Model No. **SA-XH10EE**

Subject : Block Diagram, Schematic Diagram, Printed Circuit Board & Replacement Parts List (Updates).

Please file and use this supplement manual together with the service manual for

SA-XH10PH/PR
MAIN P.C.B.

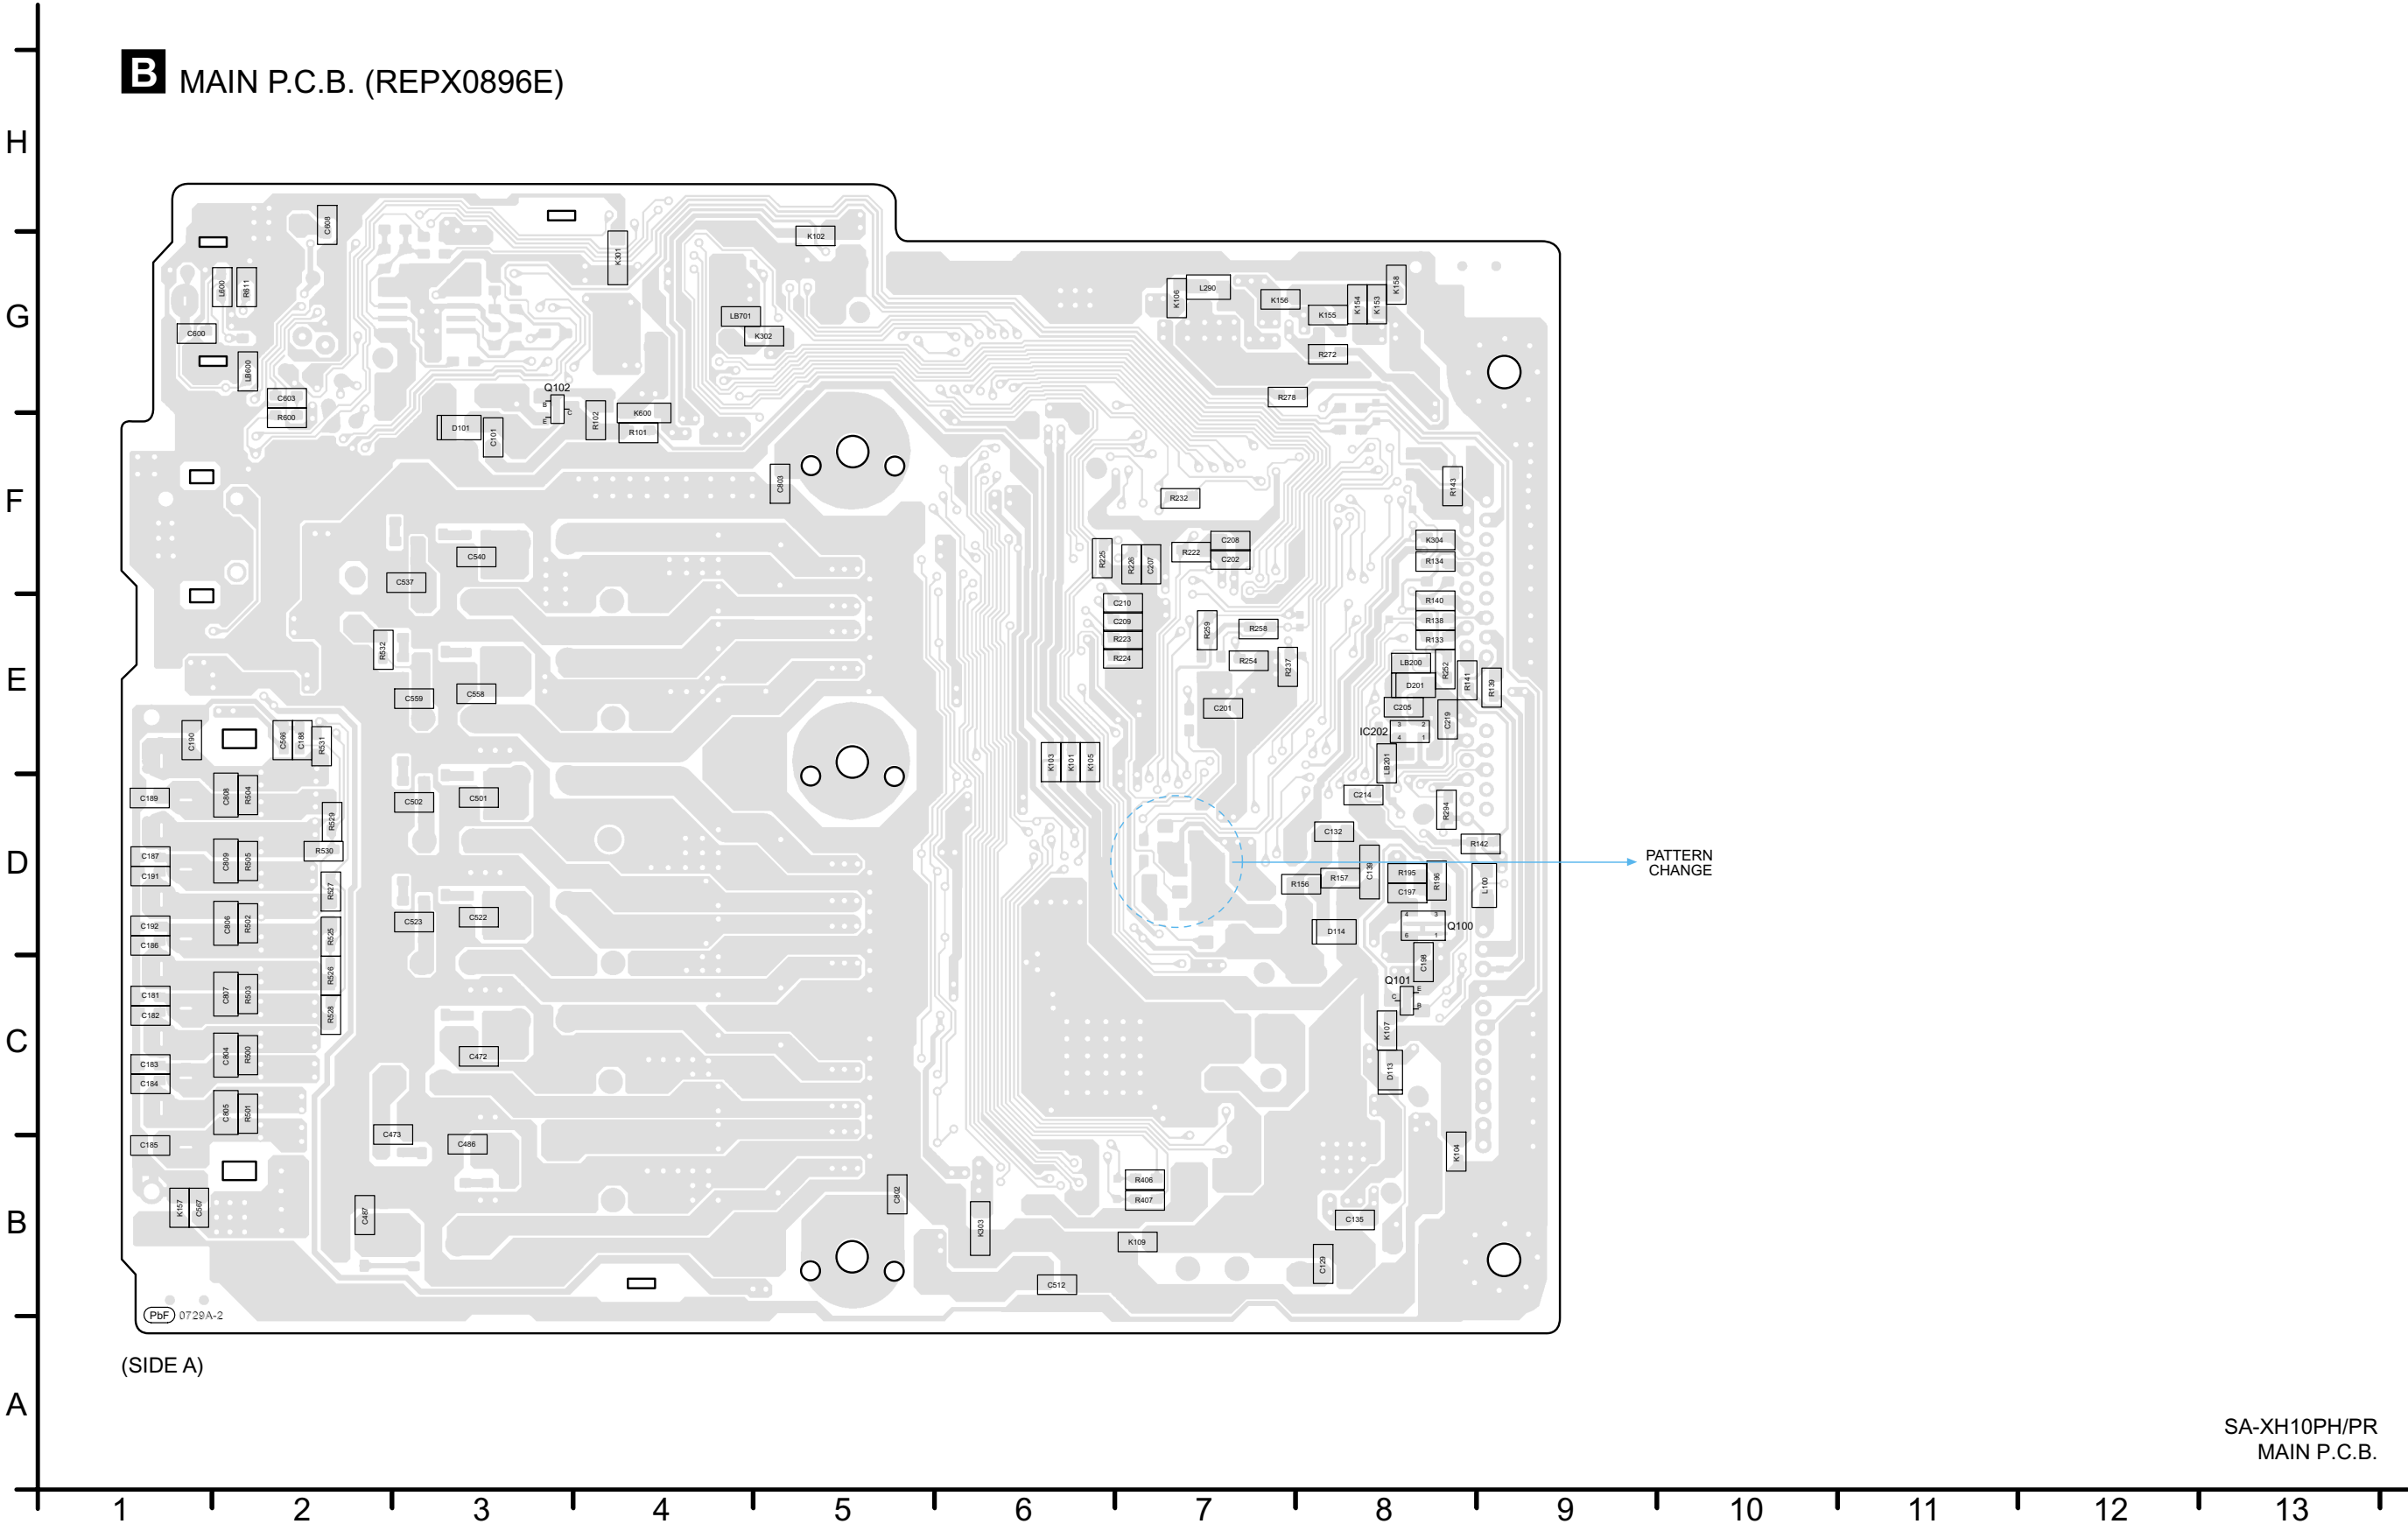
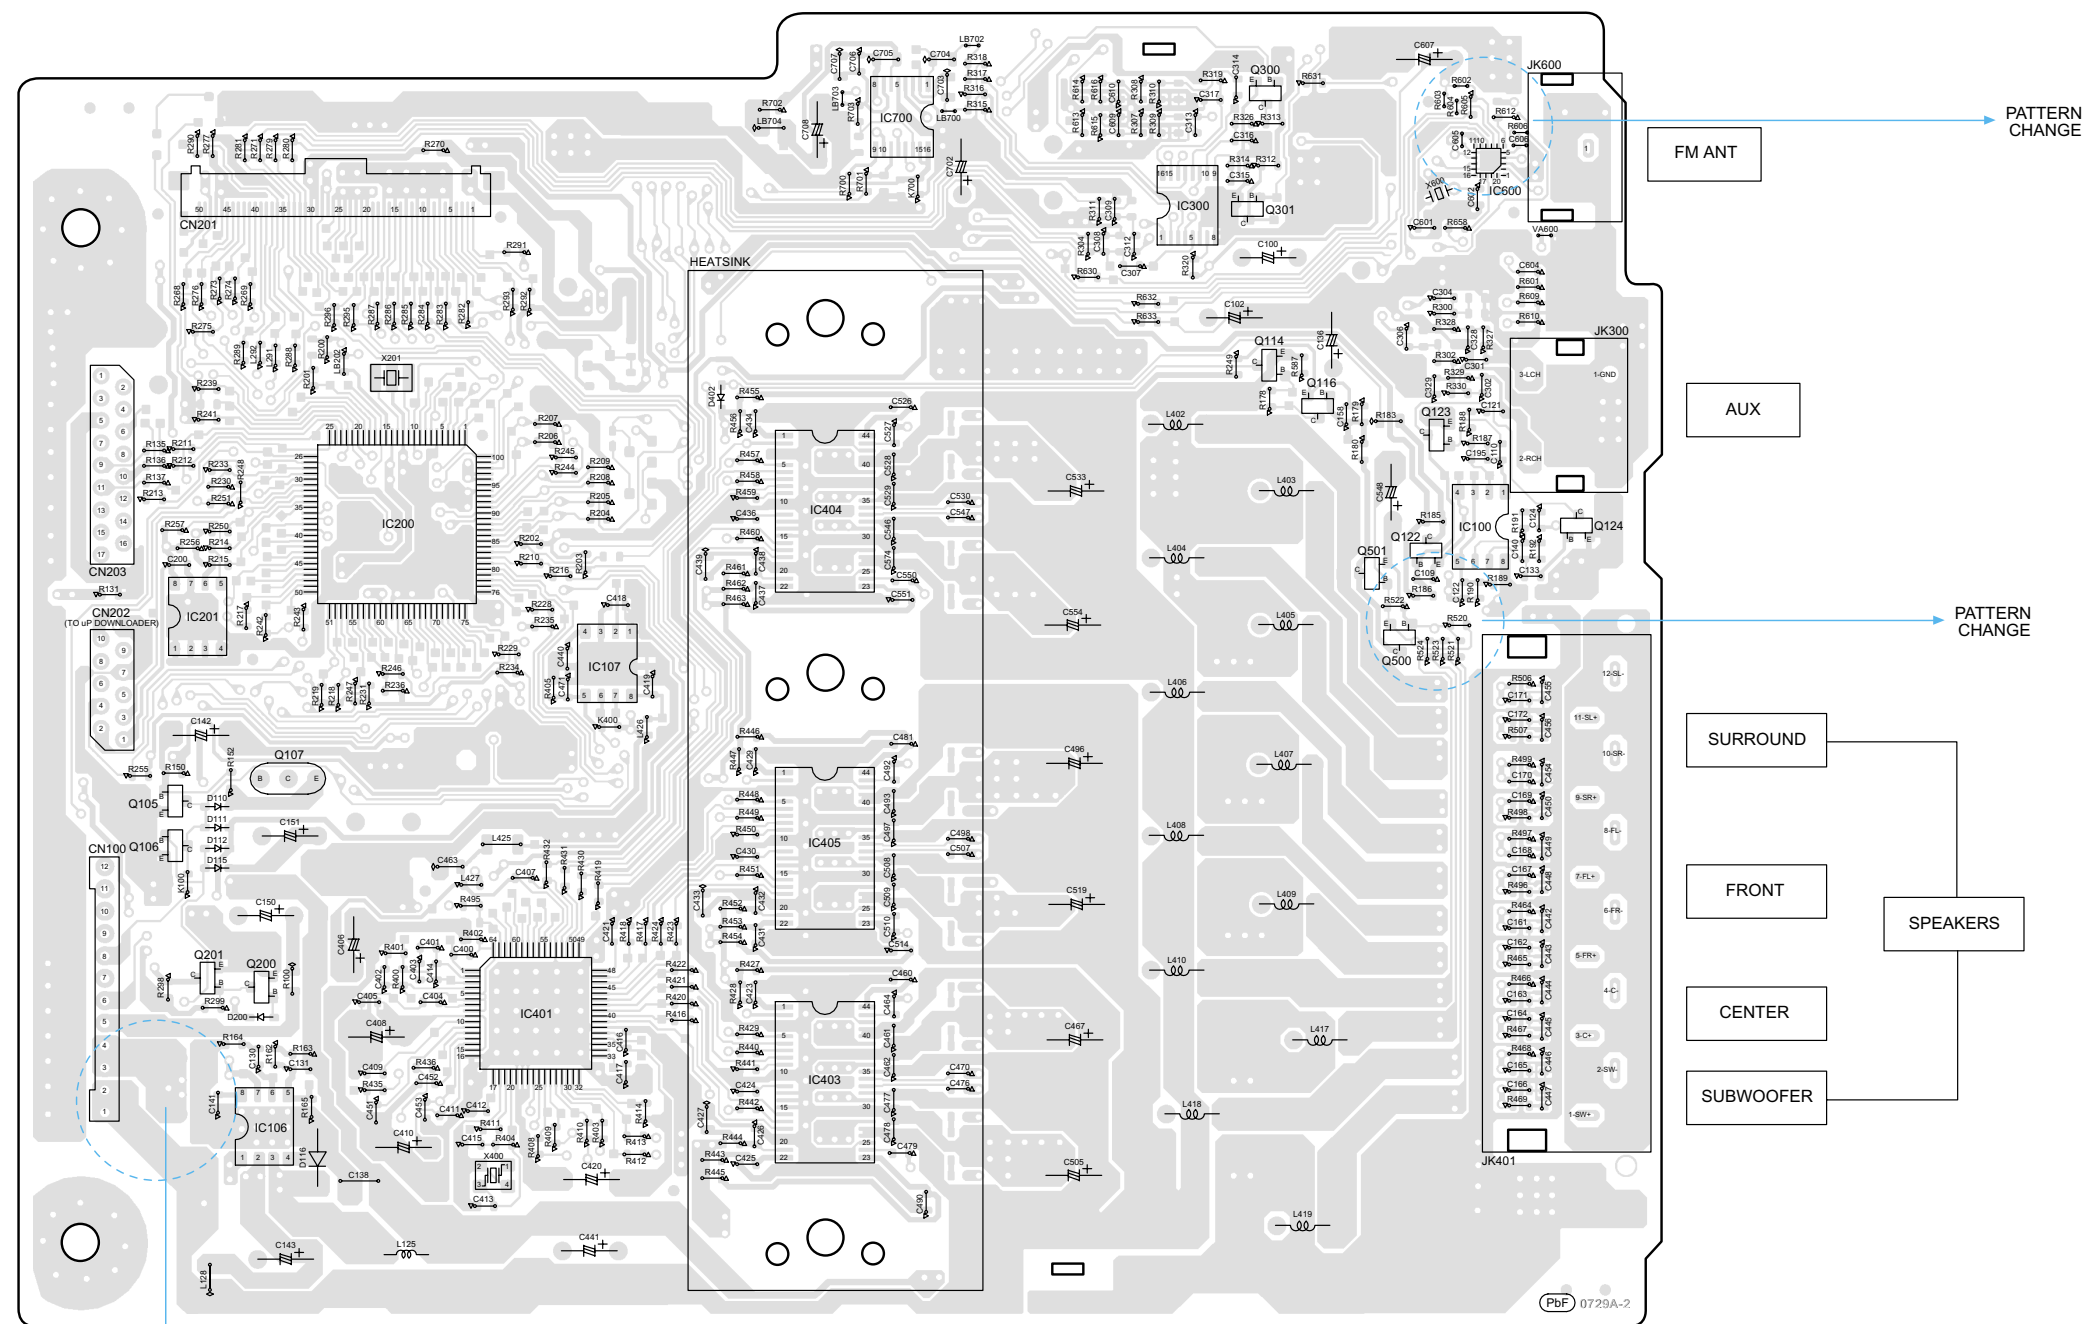
(SIDE B)
PATTERN
CHANGE
DELETE
(L421, L422)
